Technical Service Bulletin

19 Low coolant warning on; stone damage to intercooler radiator

19 13 45 2034439/2 September 3, 2013. Supersedes Technical Service Bulletin Group 19 number 13-43 dated July 12, 2013 for reasons listed below.

Figure 2. Radiator protective grill.

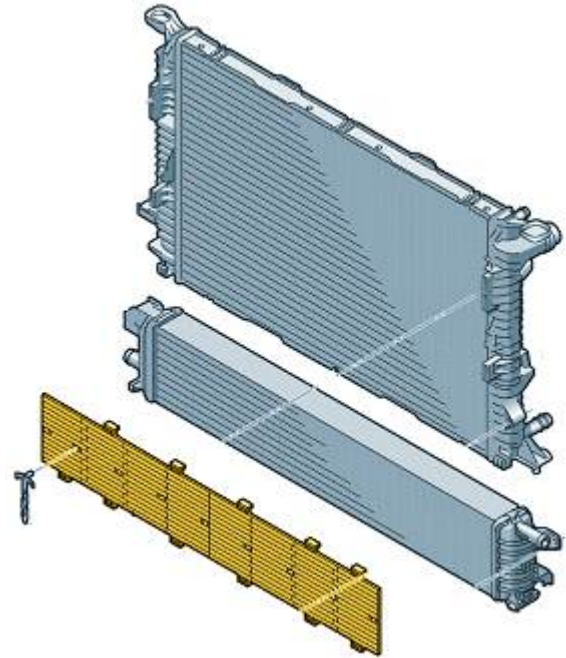
1. Verify that the coolant is leaking from the front intercooler radiator, and that the cause is stone damage.
2. Replace intercooler radiator and install a radiator protective grill (Figure 2) to prevent leaking. Follow instructions in Elsa.

Beginning with CW15 2013, a protective grill has been added.
